Adequacy Review #1 / TR-05 / Lyons Quarry / M-1977-141

The purpose of this document is to support the request to the Colorado Division of Reclamation Mining and Safety (DRMS) for a Technical Revision (TR) to the 112c Reclamation Permit Operations for Lyons Quarry (File number M-1977-141). The objectives of this document are to provide a narrative and updated Exhibits that explain the requested revisions to the approved Reclamation Plan based on changes in the mining operations at Lyons Quarry. Revised Exhibits include the following:

Figure 6 - Kleinfelder Report - Template I, Section D'-D', (Kleinfelder, 2008)

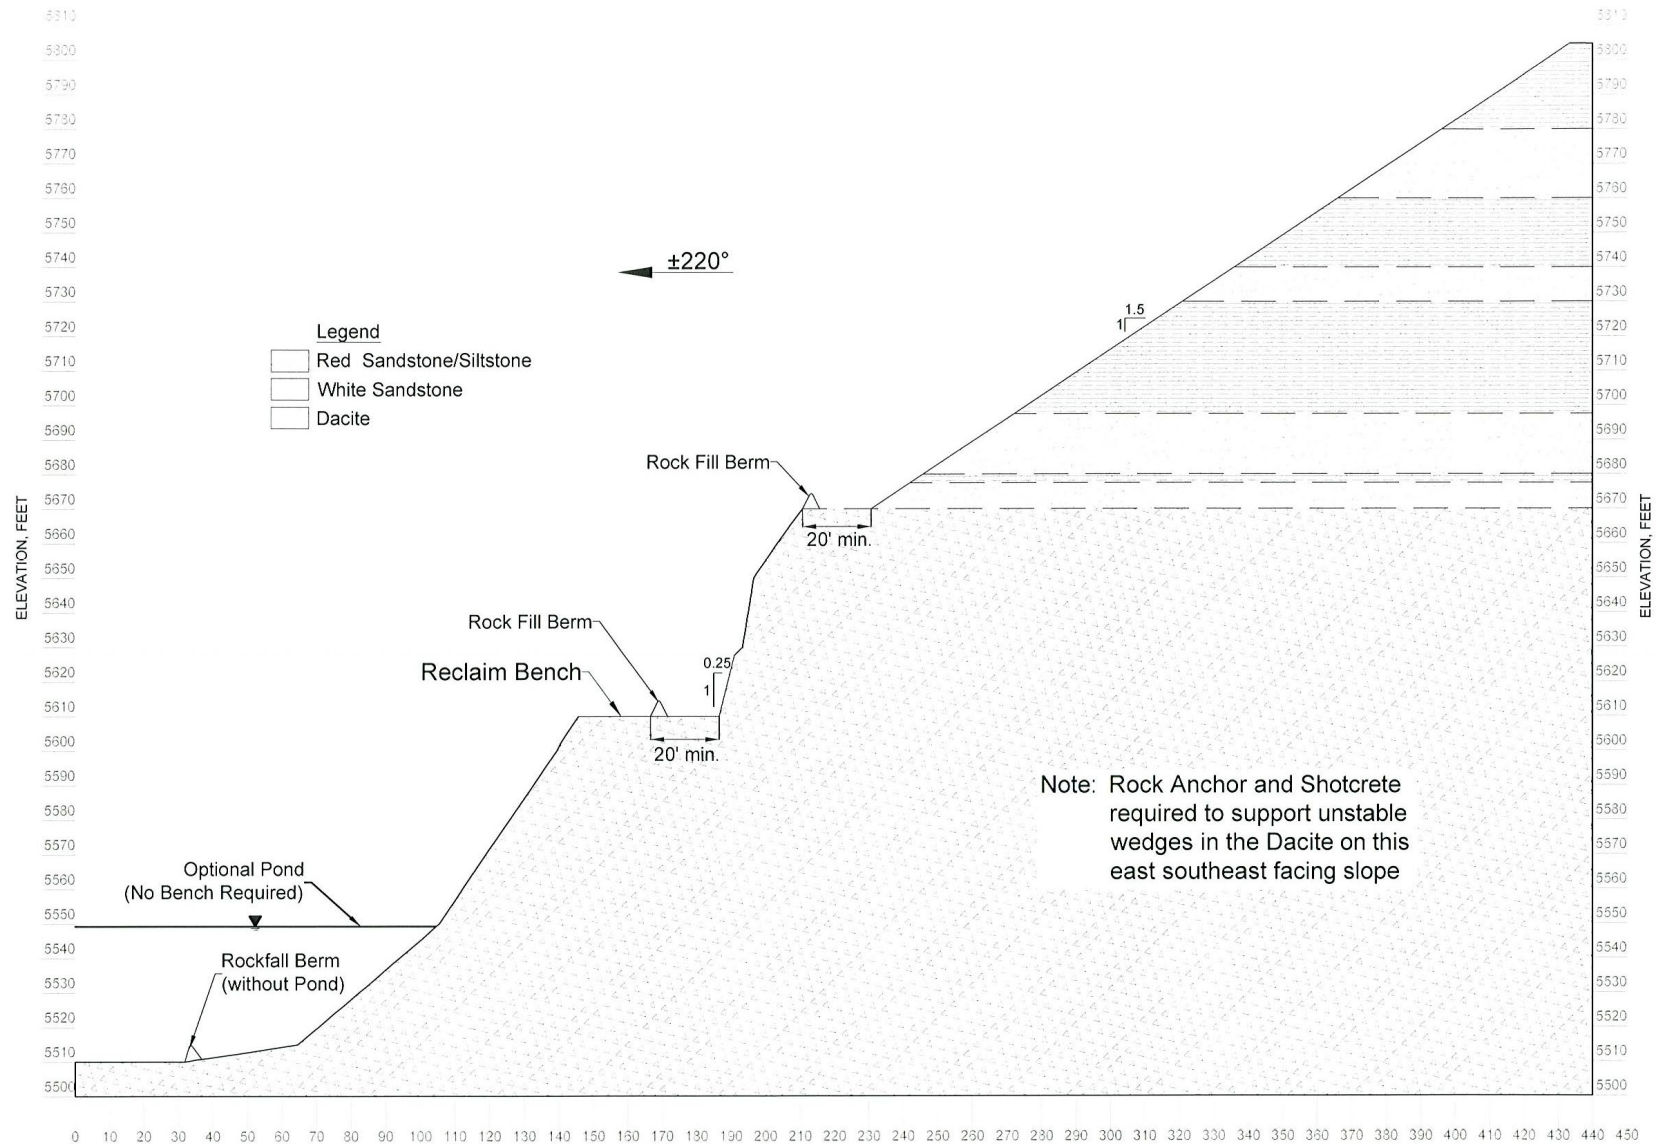
3	Under Section 3.4, the text repeatedly refers to a Figure 6. However, the Division was unable to find a Figure 6 with the submittal. Please correct and/or explain this discrepancy.	Same as #1, this figure was embedded in the text as Figure 2 and will be moved to the end.
4	On Page 12, under Section 3.4, the text discusses an alternative catchment berm alignment which would allow for closer observation of the dacite highwall. While this berm was included for consideration on the preliminary design (submitted to Boulder County), it does not appear to be part of the quarry reclamation plan proposed in this revision. Unless the operator wishes to propose installation of the alternative berm in this revision, please remove any reference to it or depiction of it in figures provided in this revision	This alternate berm will be removed from reference in figures and text.
5	On Page 12, under Section 3.4, the text mentions installing a chain link fence around a buffer zone to restrict public access to any areas of potential rockfall or fall hazards. Please provide more details in this section on the proposed fencing, including the fence height, approximate linear feet required to be installed, any additional components to be installed (e.g., fabric screen), how many gates will be installed, and what type of locking device will be installed to secure the gate(s).	This information is in the cost table and specifications but will be added to the narrative.

Attachment B.
Site Grading Plan

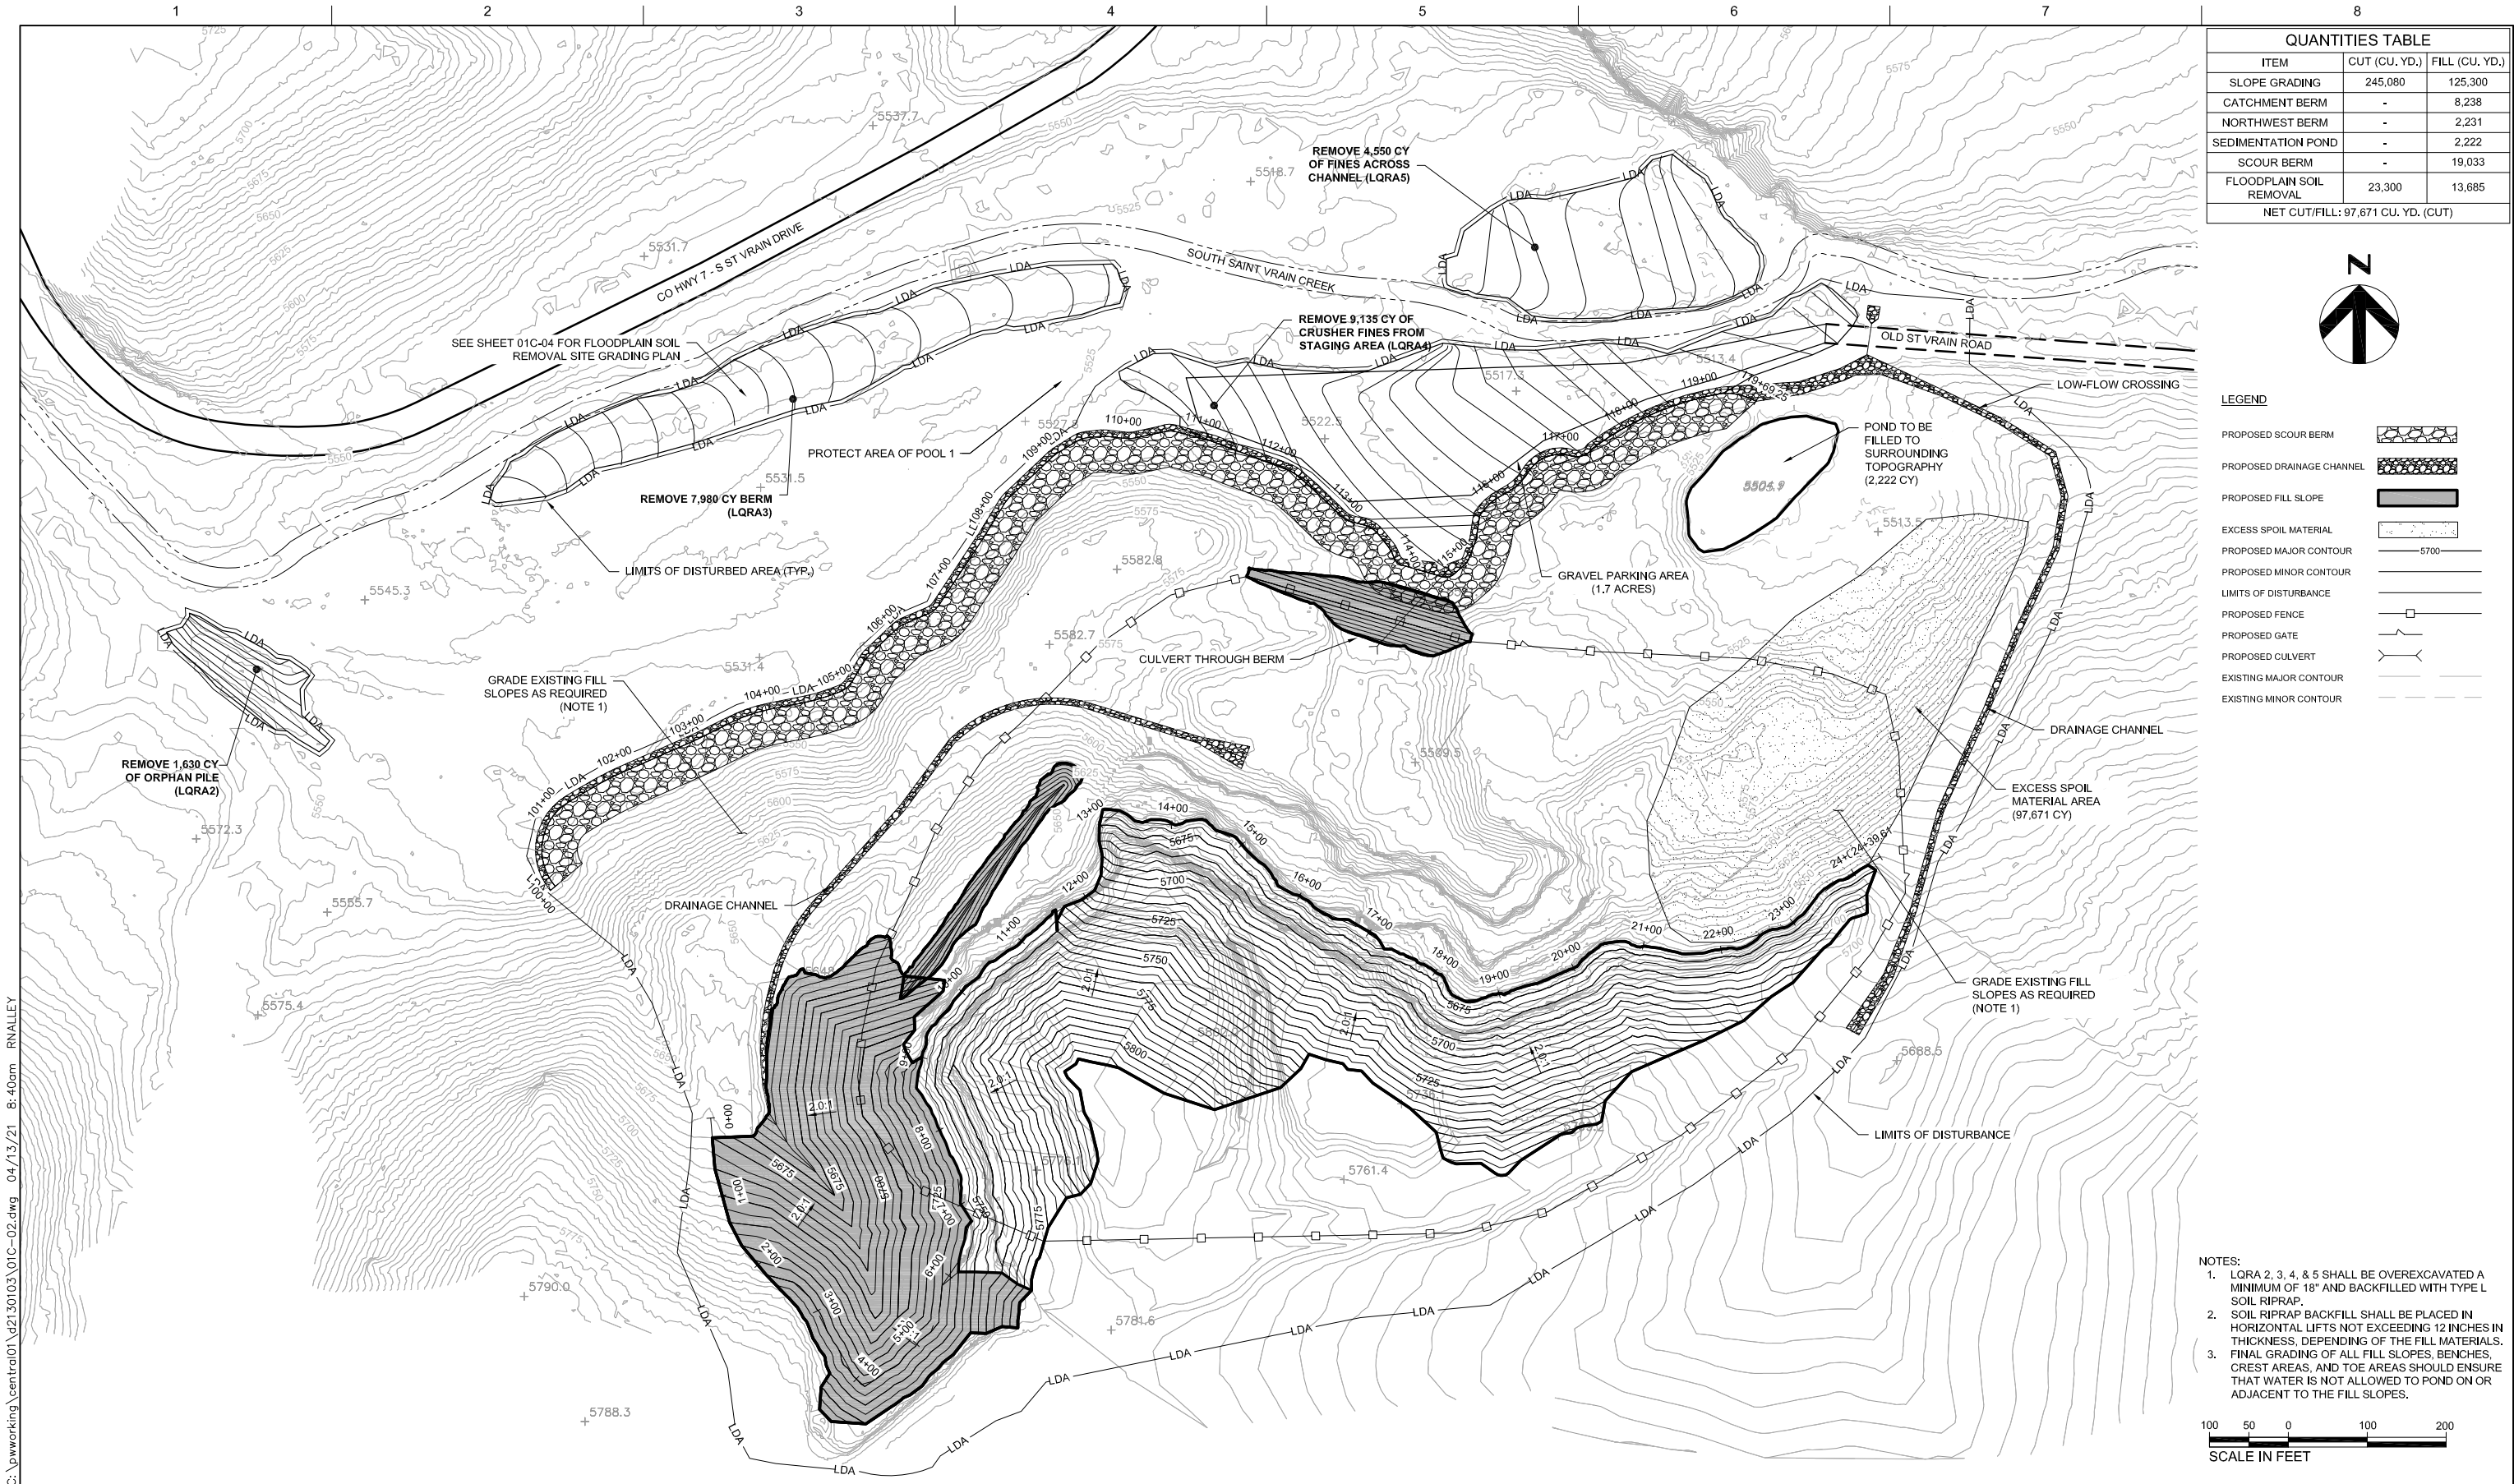
10	In Attachment B, on the figure labeled "Final Grading Plan", please ensure all features shown on the figure are labeled or described in the legend. For example, there are different patterns depicted for the features which do not correlate to the items described in the legend. Additionally, there is a feature depicted with a line and boxes which the Division believes is the proposed chain link fencing. However, this feature is not labeled or described in the legend. Finally, on this figure and/or on the figure labeled "Final Grading Profile, Section & Details", please show the final proposed gradient of all reclaimed slopes in the Horizontal:Vertical format (including the sections of the highwall proposed to remain as-is after scaling and installation of rock bolts).	Legend will be updated for the grading and restoration plans. Add H:V gradient to profile section callouts for proposed grades. 2:1 in all reclaimed areas and steeper (1:1 - 0.5:1) for highwall areas.

CIVIL OVERALL RECLAMATION PLAN & DETAILS

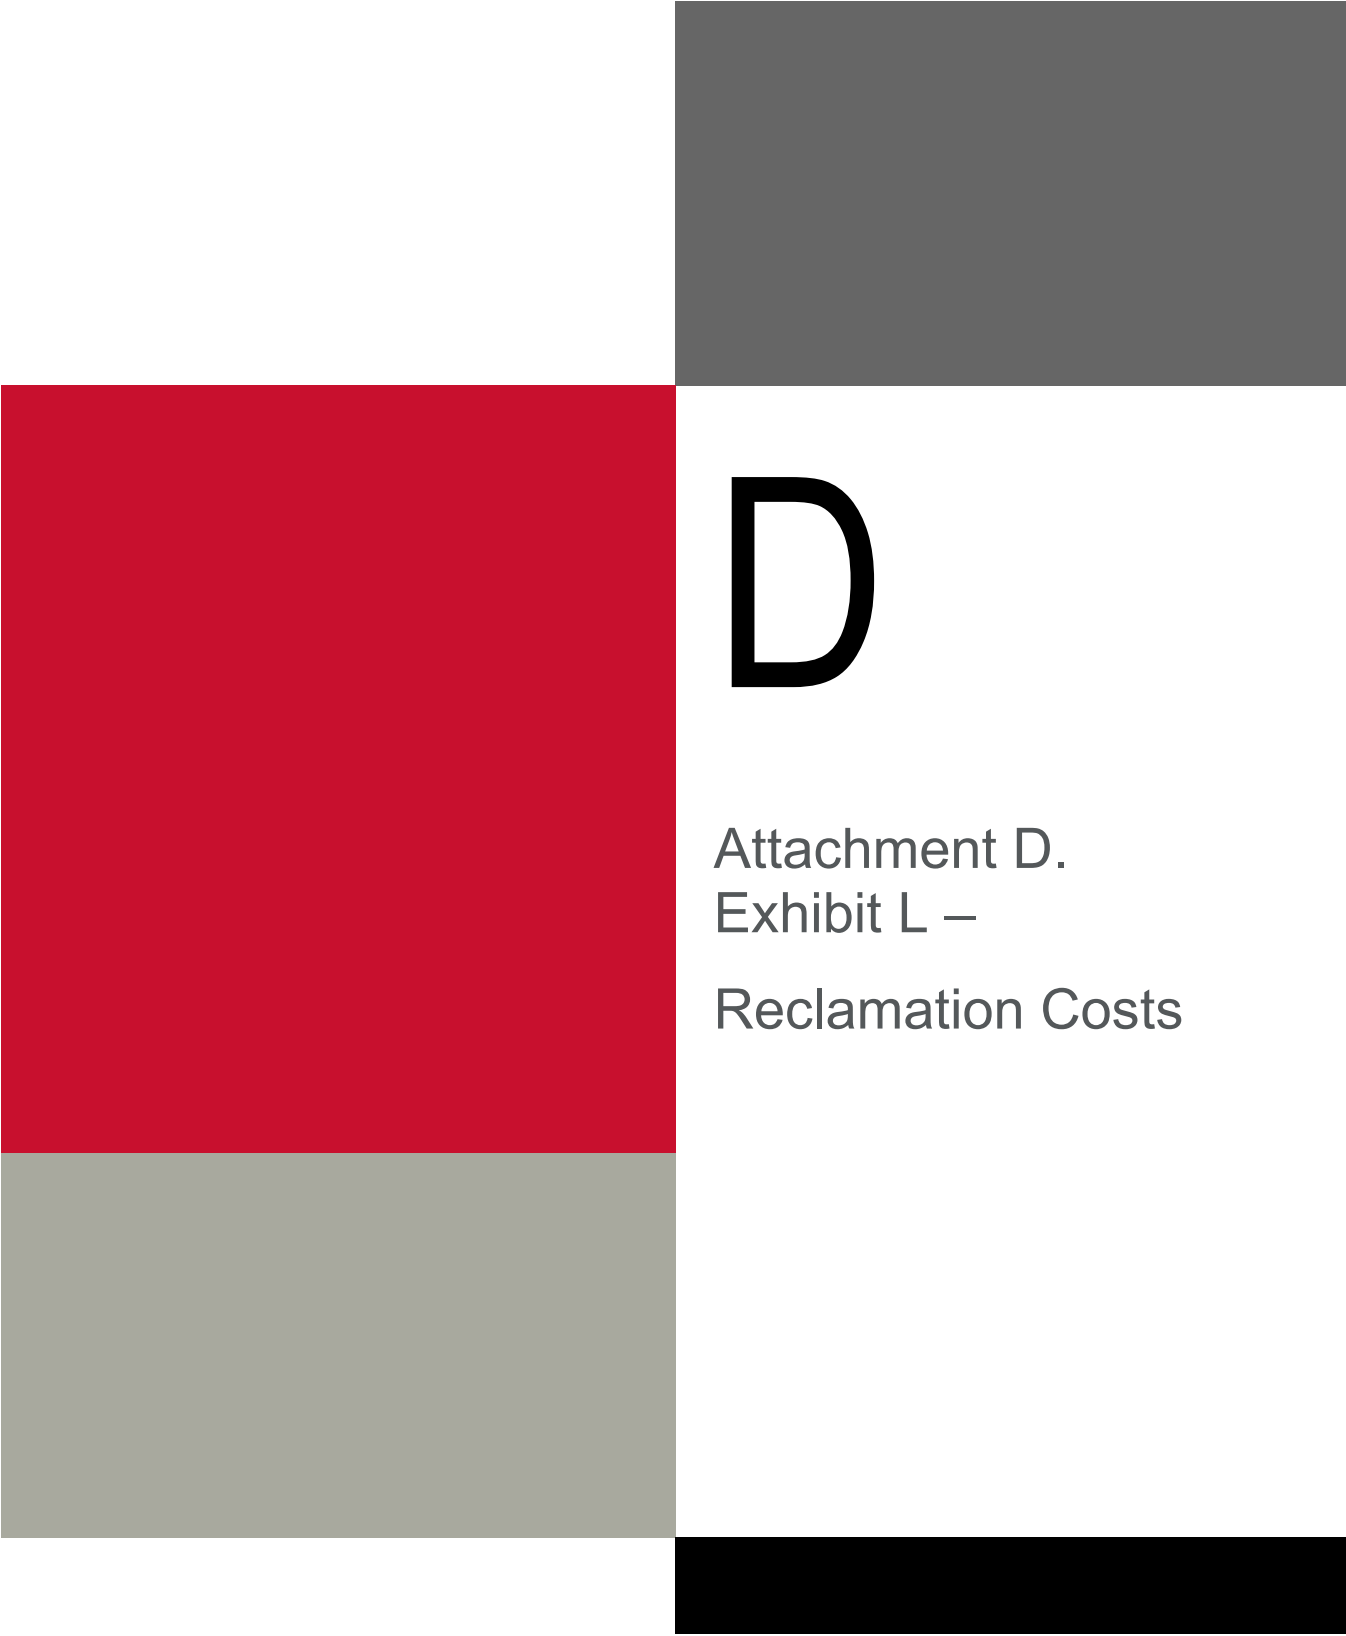
11	1) In Attachment C, on the figure labeled "Overall Reclamation Plan & Details", please ensure all features shown on the figure are labeled or described in the legend. For example, the Division was not able to correlate the pattern shown for the catchment berms to a description in the legend. Additionally, there is a feature depicted with a line and boxes which the Division believes is the proposed chain link fencing. However, this feature is not labeled on the figure. Finally, this figure appears to show the dacite portions of the highwall which are proposed in this revision to remain as-is (steeper than 2H:1V) to be mulched for reclamation. This contradicts the reclamation plan described in this revision which includes not revegetating these portions of the highwall. Please correct this figure and/or the text accordingly.	Included a note that on the plan that the mulch area slopes "vary" but will delineate areas specifically along the highwall which will not be included in the revegetation estimate.
